71-9196

SUBJECT: TRANSFER OF AND AMENDMENT TO US NUCLEAR REGULATORY COMMISSION CERTIFICATE OF COMPLIANCE NO. 9196 FOR THE MODEL NO. UX-30 PACKAGE

SAFETY ANALYSIS REPORT FOR
MODEL UX-30 PACKAGE
PUBLIC VERSION

REVISION 1

ENERGYSOLUTIONS	
UX-30 OVERPACK	
C-110-B-57922-0002 4

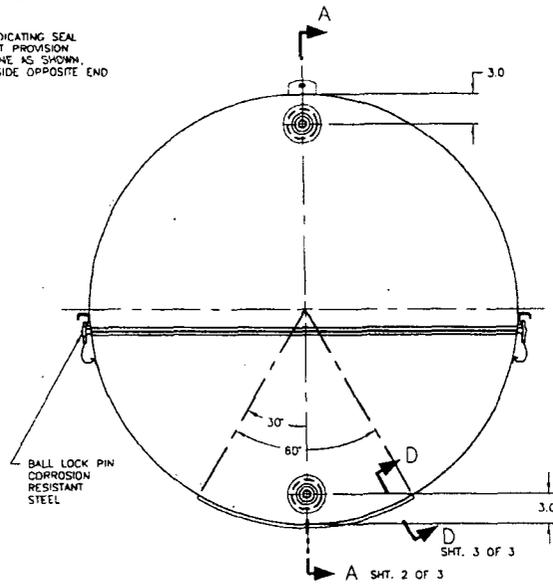
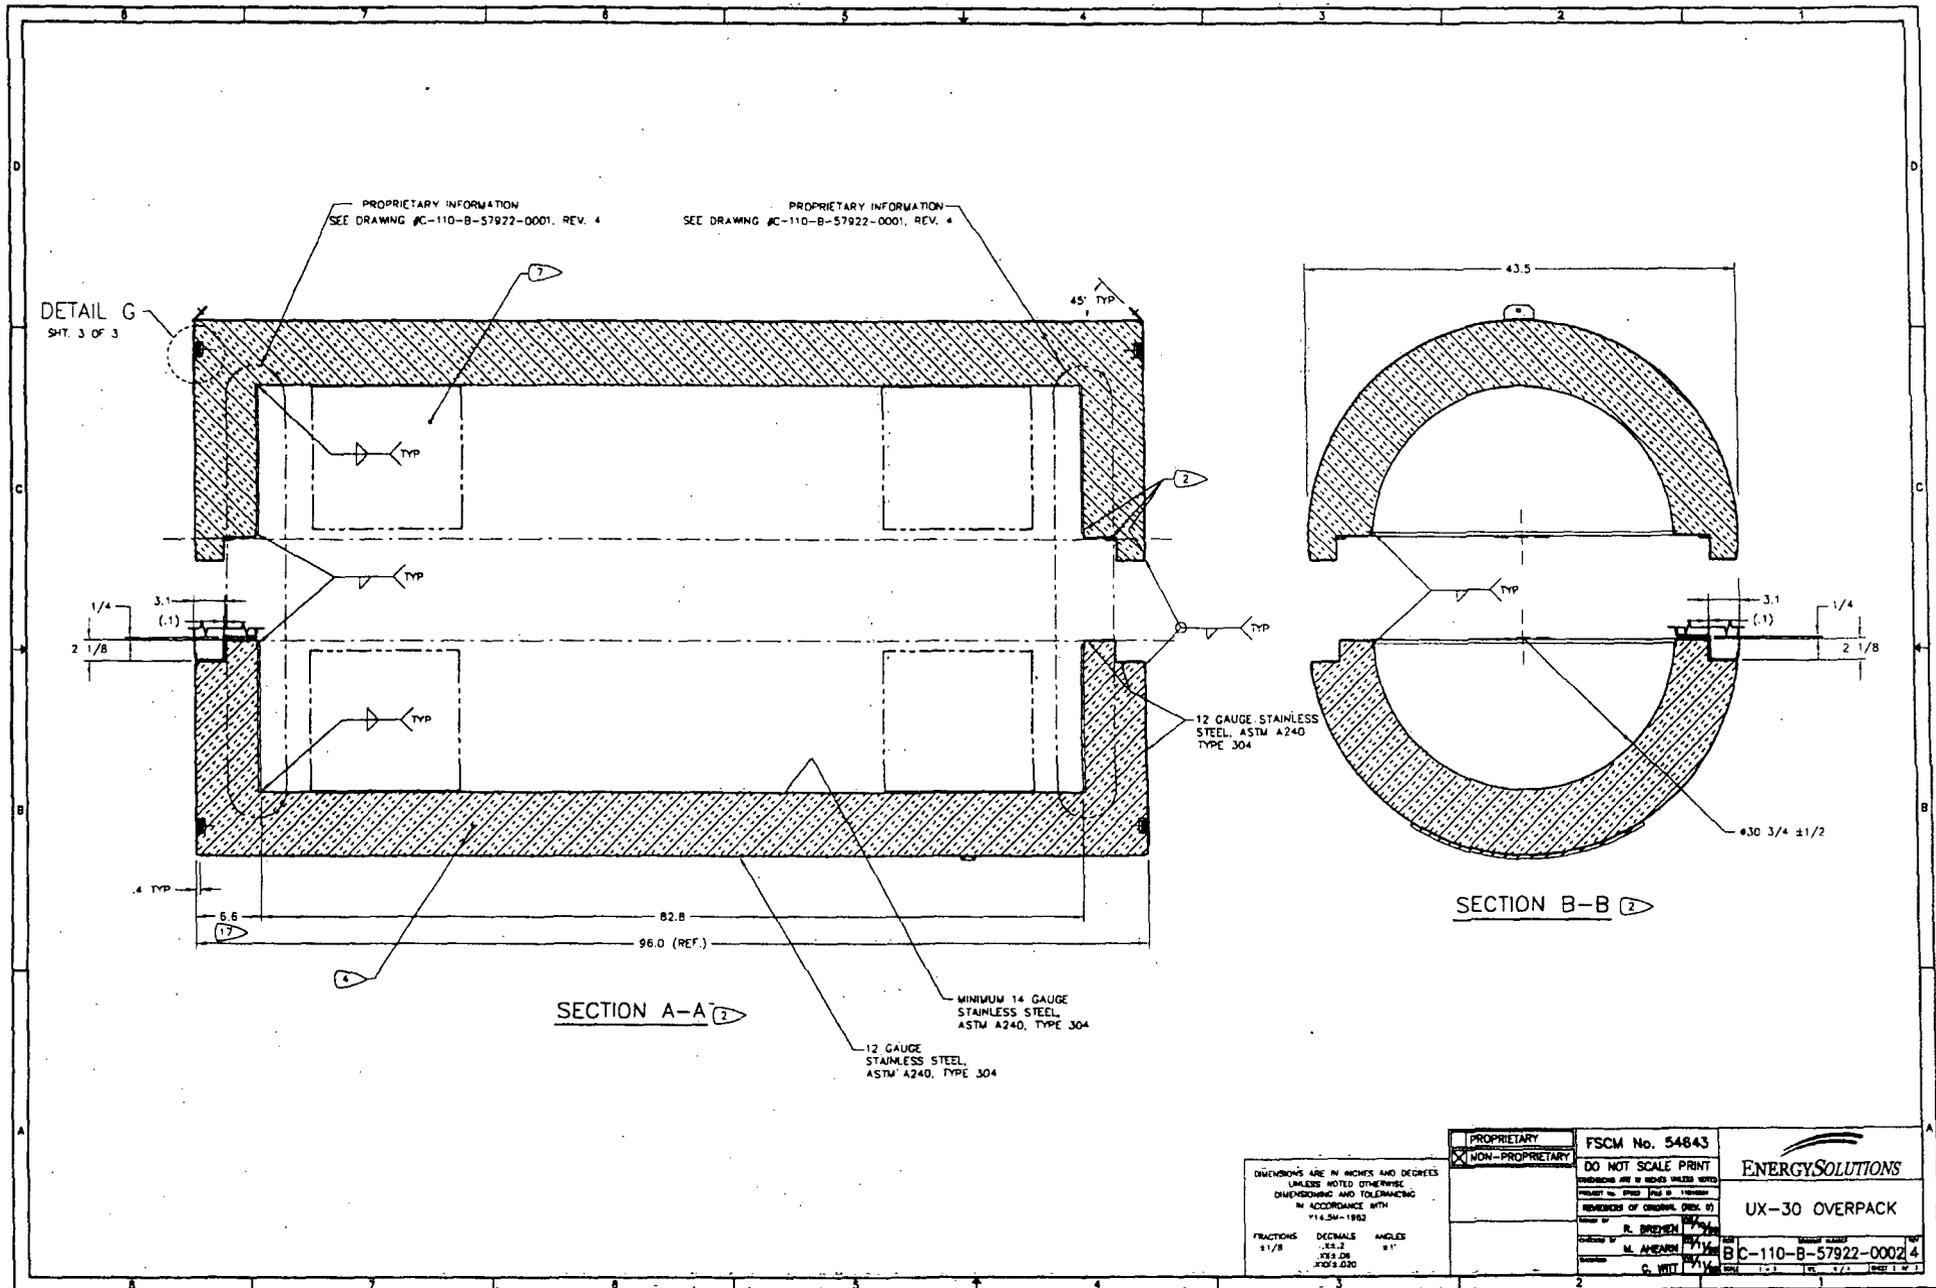
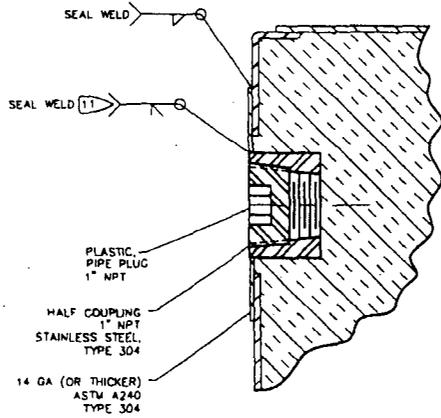
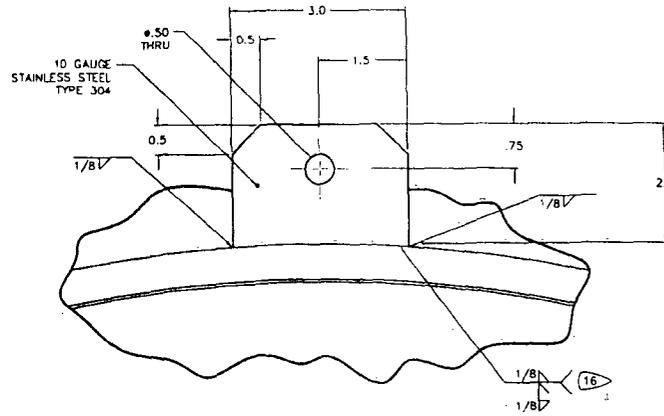
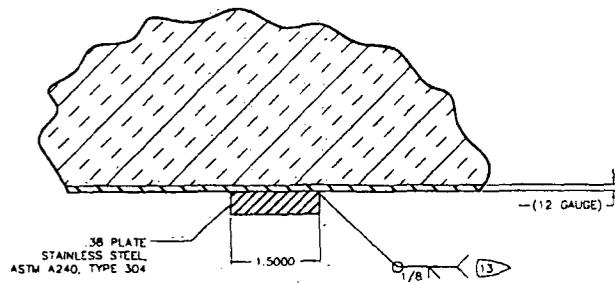
5. Drawings
Drawing C-110-B-57922-0002, which is included in the public (formerly non-proprietary) version of the SAR, is referenced in the CoC. The drawing has been revised to change several notes and the title block from Duratek to EnergySolutions. In addition, two weld symbols on sheet 2 (zones B/7 and C/7) were corrected to conform to the proprietary drawing. These symbols were inadvertently omitted from the public drawing and have been added to reflect the package as fabricated condition, i.e., in accordance with the proprietary drawing. Proprietary Drawing C-110-57922-0001, which was previously included in the proprietary version of the SAR, is provided in the non-public version of the SAR (Attachment 3) as both proprietary and security-related sensitive information. This drawing is not currently referenced in the CoC and we request that this drawing continue to be treated in this manner. The drawing has been revised to change the title block to EnergySolutions.
